# ATTACHMENTS ORDINARY COUNCIL MEETING

# **PLANNING AND SUSTAINABILITY**

PS04-09/24	<b>Consideration of Precinct 15 - Central Mariginiup Local Structure</b>
	Plan Following Advertising

### **Schedule of Modifications:**

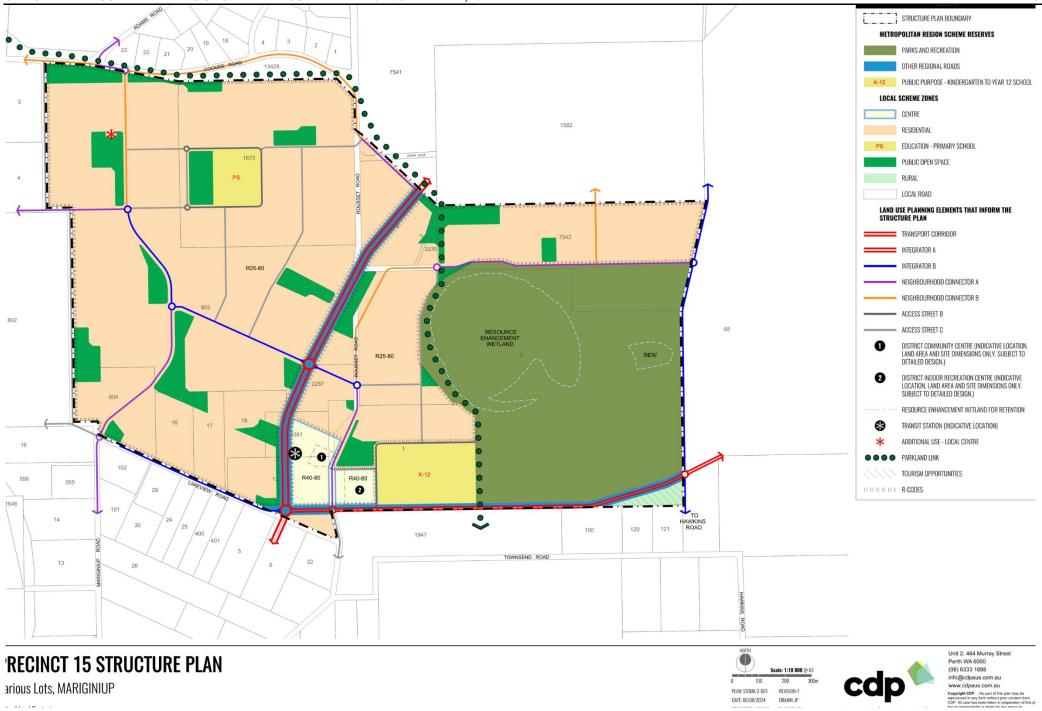
7.9	Concern is also raised that both school locations are currently proposed on existing wetlands. Additionally, Figure 15 of the Post Development Surface Drainage of the LWMS and Appendix D of the Engineering Report seek possible allocation of a drainage basin and pump station on POS 9. Further, a pump station is also identified on the K-12 school site.	These are Multiple Use Wetlands, not required to be protected and not proposed to be retained. As such, these sites will be earthworked to support development and the school sites (physical site requirements) will be delivered in accordance with OP2.4.	Noted. In accordance with the Proponent's comments, the proposed school sites will be required to be earthworked to accommodate development. Administration recommends as part of its resolution that prior to the approval of the LSP that the DoE is further consulted to confirm the sufficiency of the school sites proposed.	It is recommended that as part of the resolution, that prior to the adoption of the LSP that further consultation is undertaken with DoE to confirm the sufficiency of the education sites.

which may impact on the developability of these sites. Figure 13 – Wetlands of Structure Plan Report indicates that the primary school and 'K-12 school sites fall within the Multiple Use Wetlands identified as UFI 15022 and UFI 14252 respectively. In addition, Figure 3 – Acid Sulphate Soil Risk Nap of Environmental Assessment Report indicates that the PS 1 and K-12 sites are impacted by Class 1: High to moderate Acid Sulphate soil risk.  Given that the Multiple Use Wetland generally provides essential hydrological functions, clarification is sought on whether there would be any development limitation on these school sites and that they are geotechnically sound and not subject to inundation, erosion or extension on-site earthworks.	proposed POS areas.  Geotechnical and physical considerations will be addressed through the bulk earthworks and engineering processes, to ensure the site is suitable for its intended use. This is standard practice.	In addition to the above, Administration's resolution will require that further consultation is undertaken with the Department of Education to ensure sufficient educational sites are provided.

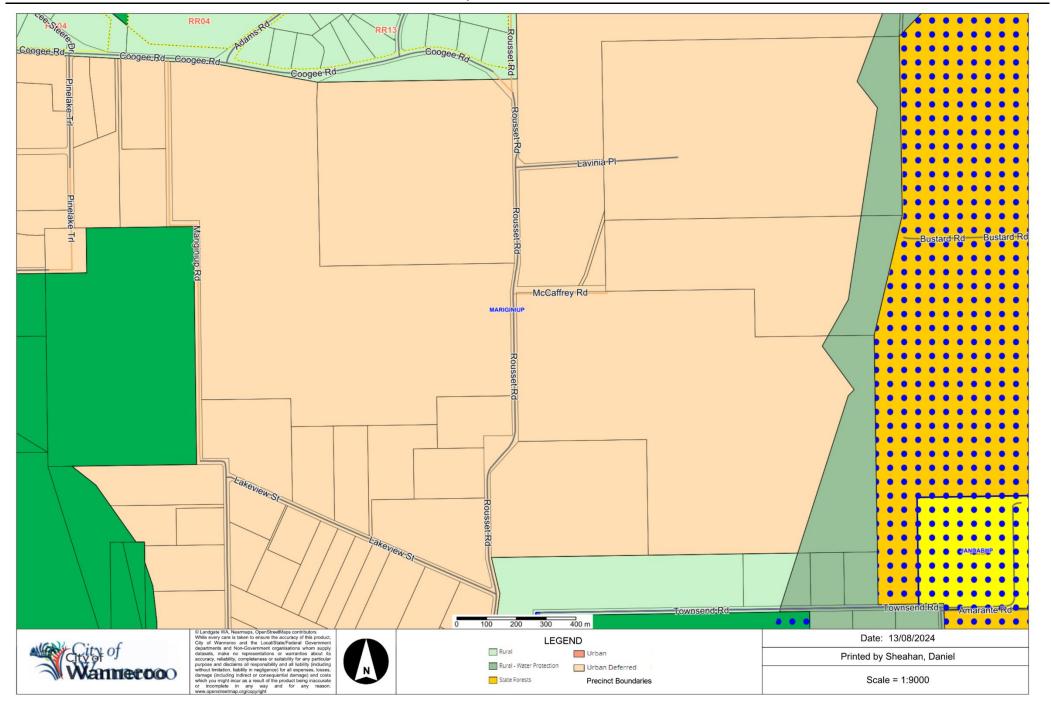
7.13	Road reserves adjacent to school sites shall have appropriate carriageway width and integrate pedestrian and cycle paths via a	Figure 25 can be revised as required to allow for DUP's on roads adjacent to school sites. This is consistent with advice	Administration concurs with the comments of the DoE.	It is recommended that Figure 25 as contained within Part 2 of the LSP and the TIA are

dual-use/shared path. However, Figure 25 – Path Network of the Structure Plan Report indicates that dual use paths have not been proposed within the road reserves adjacent to public school sites although these sites will be served with Access Street B (17.9m wide).	provided by CoW on the TIA regarding shared paths around schools.		amended to indicate that a shared path is required.  In addition, it is recommended that Part 1 of the LSP and the TIA are amended to incorporate road reserves in accordance with Local Planning Policy 5.3: East Wanneroo.
		Department of Transport	(Advice)
